This document summarizes purpose, new features of the Software Version: 53 for the Projects Bordline CC1500 AC 25kV M 2300 fitted in 1500 Amp IGBT Based Traction Converter equipped with PEC Trac Controller. This is the released version as per the feedback from previous Test Version 52.

2 Release Notification

Prepared	Sutanu Ganguly	24.03.2022	Project	CLW 3-Phase Locomotives	No of pages 8	
Reviewed	Tarun Jain	30.03.2022	Title	Change note for Software Ver-53		
Approved	Ramu S	30.03.2022	Converter	Bordline® CC1500 AC 25kV M2300 004 B01		
Department	MOTR		Document No.	Language	Rev.	Page
 ABB India Ltd.			2UDB271271 ZAB 935	en	-	1

Non-Generation of motor pop-up in case one motor is already blocked by Speed Sensor Failure.

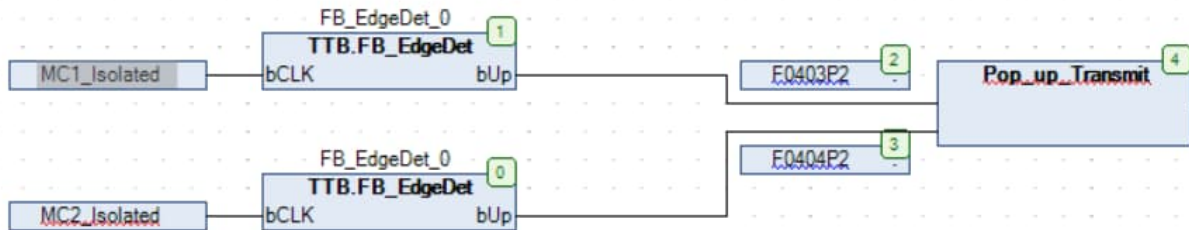
Problem: Secondary pop-up message suppressed during transmission as 1st pop-up bit remains high all the time.

Solution: Added Transmission with positive edge detection so that the transmission time for one pop-up is fixed and the subsequent next pop-up is not suppressed.

1. Interruption of secondary DDS Message during Fault Condition, wrong DDS Generation in some faults.

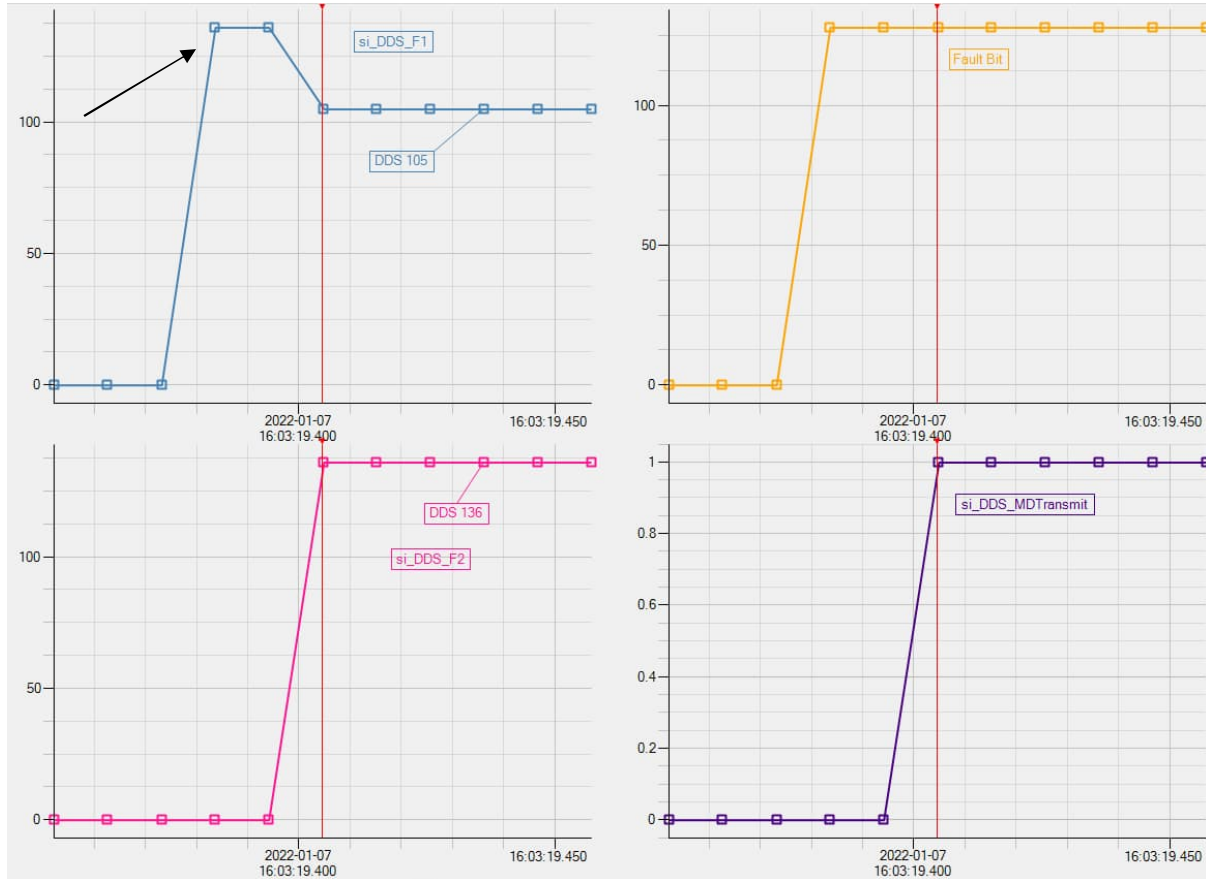
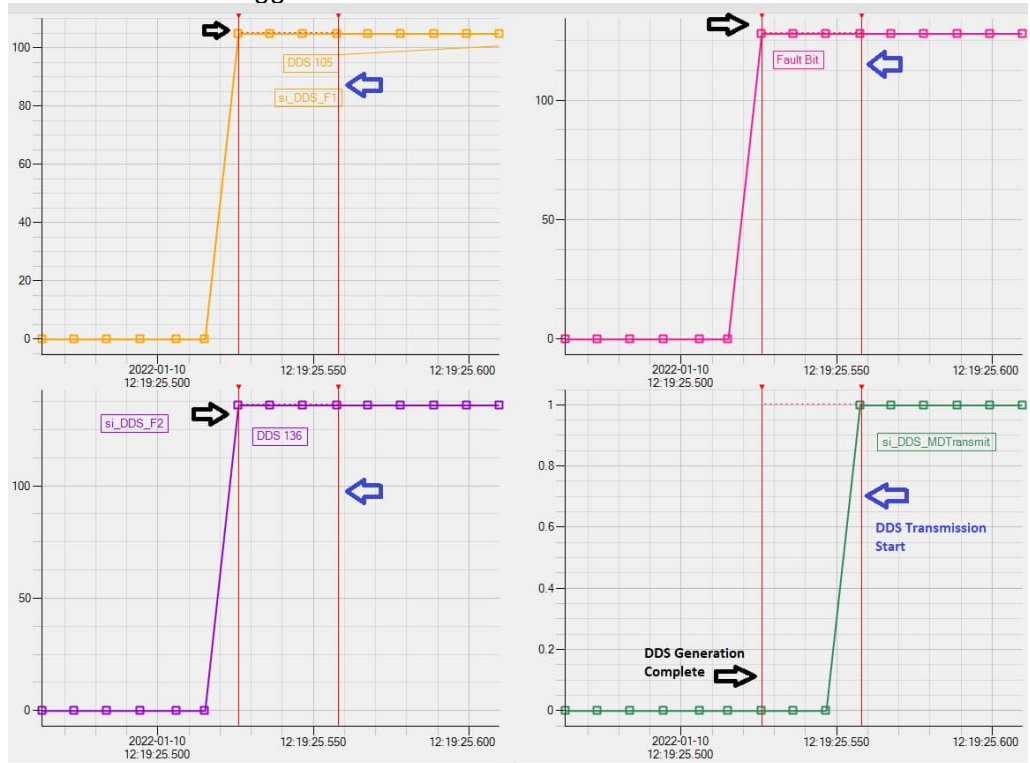
The DDS generation and Transmission was occurring at the same time, therefore some DDS Tasks were not transmitted. The Red line is placed in all the graph for better visual understanding. DDS considered below are SLG1:0105-Dist.temp sensor motor-1, SLG1:0136-TM1 Boggie-1 Isolated Also the F1 Fault was trying to generate 2 DDS at the same time which is not ideal and provides junk data.

The Transmission task is delayed by 2 Tasks so that the Transmission can start after the DDS generation is complete. Also the DDS generation Fault Word is corrected to generate one fault message per word. Now we observe the correct generation and transmission. Similar issues were reported with DDS for UD_Failure, LC_isolation and speed_sensor_failure which will also be addressed by this update.

2. MC Overcurrent in Dynamic Conditions.

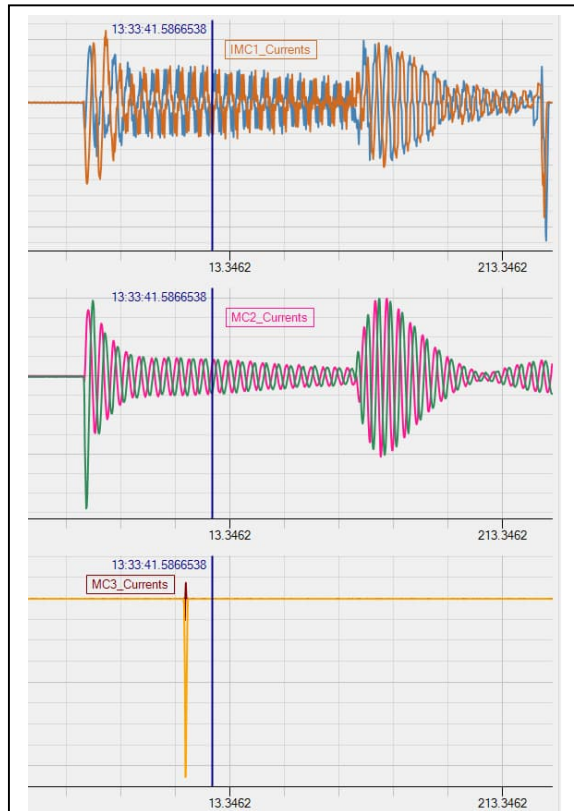
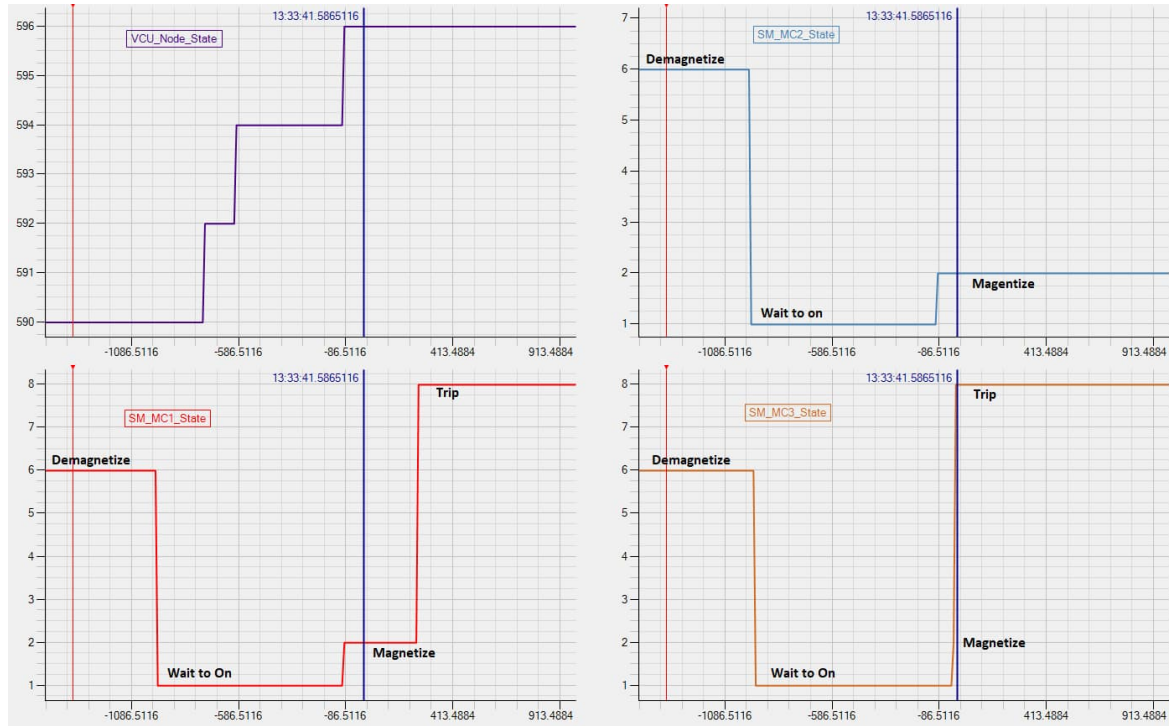
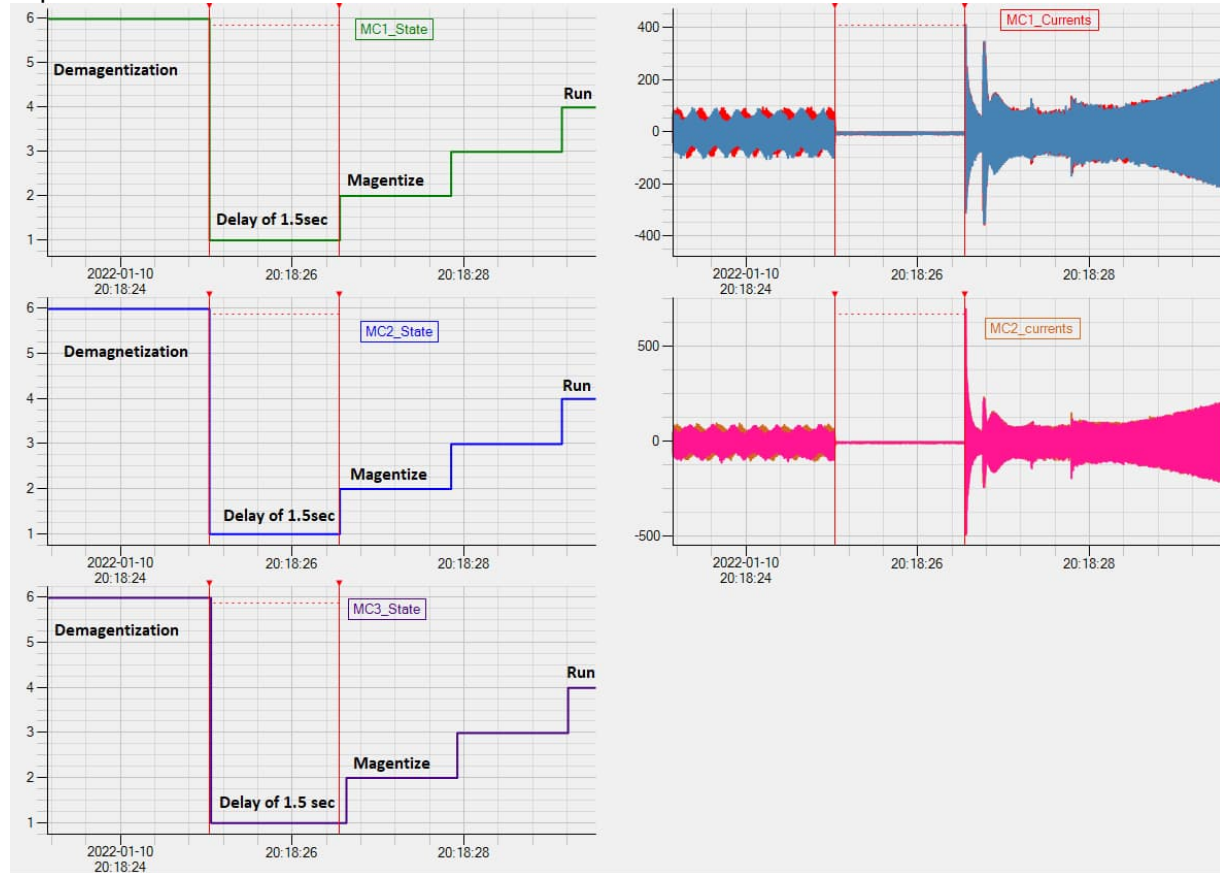
4 Cases of Mc Overcurrent reported which is analyzed. All Cases are reported at dynamic operation speeds. All cases show the trend of high magnetization current in the motors during pulsing when the motor completed a prior demagnetization cycle.

The MC1 goes into magnetization and remains in magnetization for approx 350msec and then trips with an over current.

MC2 shows a successful magnetization and it continues to pulse

MC3 trips instantaneously when it starts magnetization.

On Delay of 1.5 seconds introduced between successive demagnetization and magnetization cycle. This should improve the demagnetization of the motor and help to prevent the dynamic pulsing transients.

3. LC Overcurrent in Dynamic Condition.

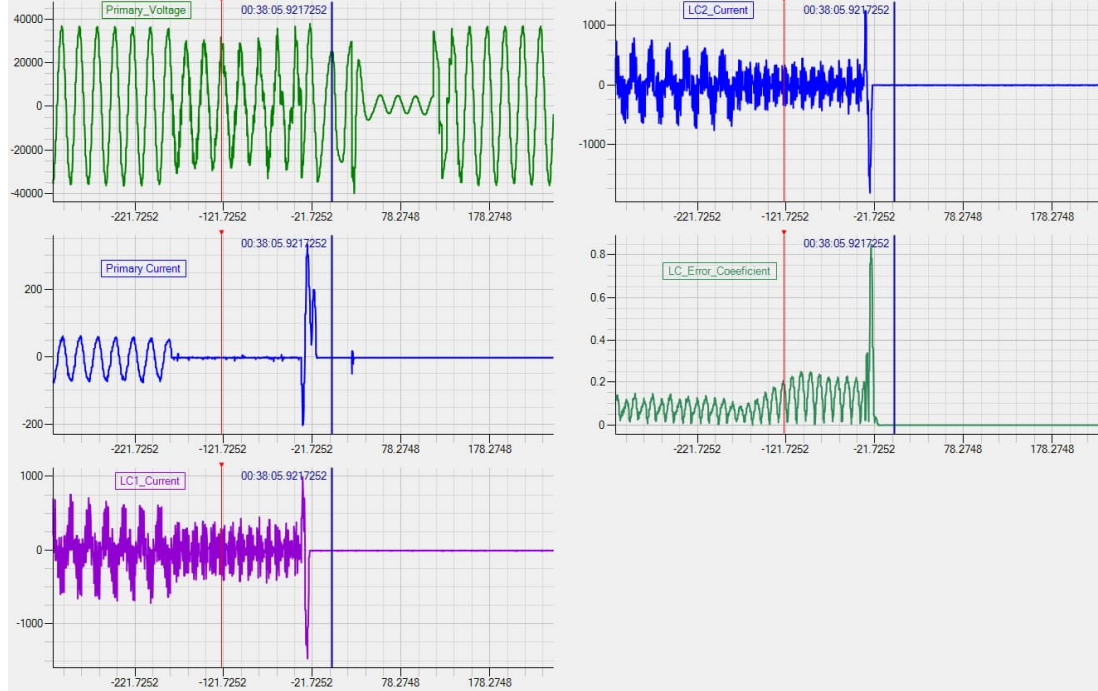
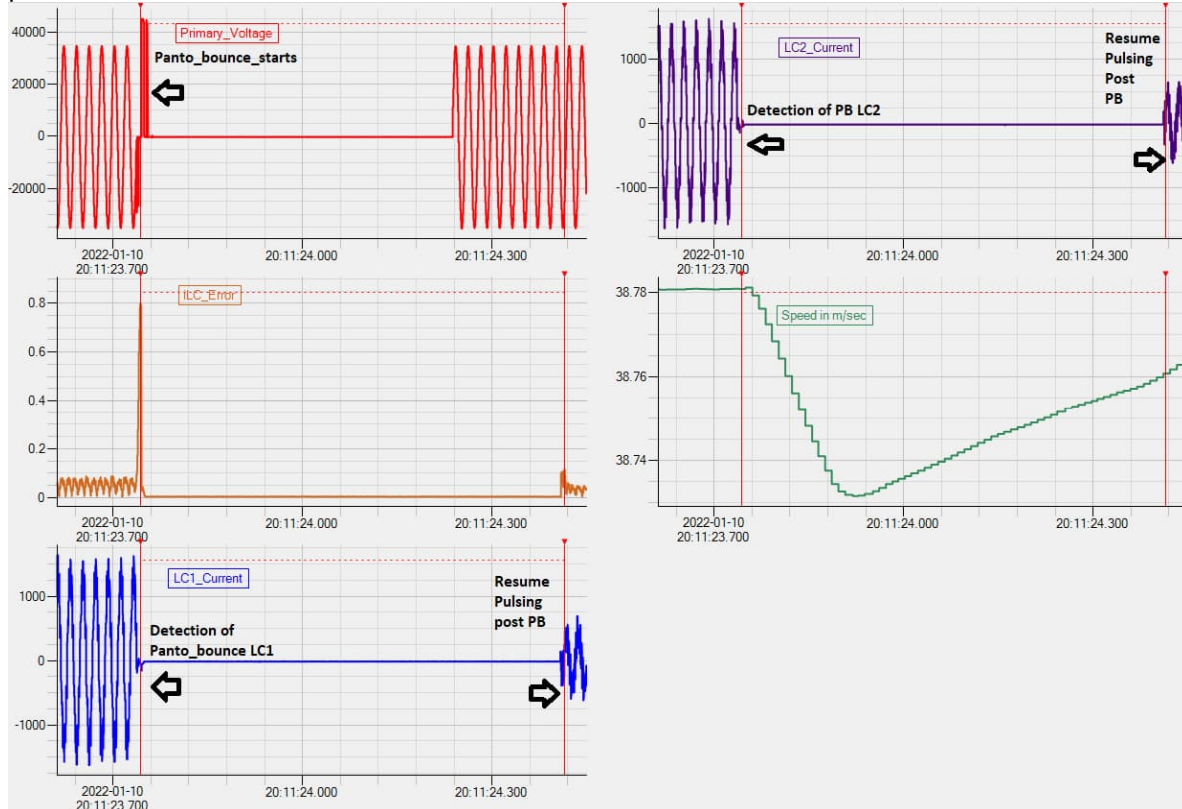
Problem: Non detection of pantobounce resulting in Line Converter pulsing and trip.

Introduction of additional monitoring of pantobounce considering Difference in P.U current for each Line Converter which if exceed 0.2.

Below shows the testing result in the Real Time Simulator with the new software and different pantobounce conditions.
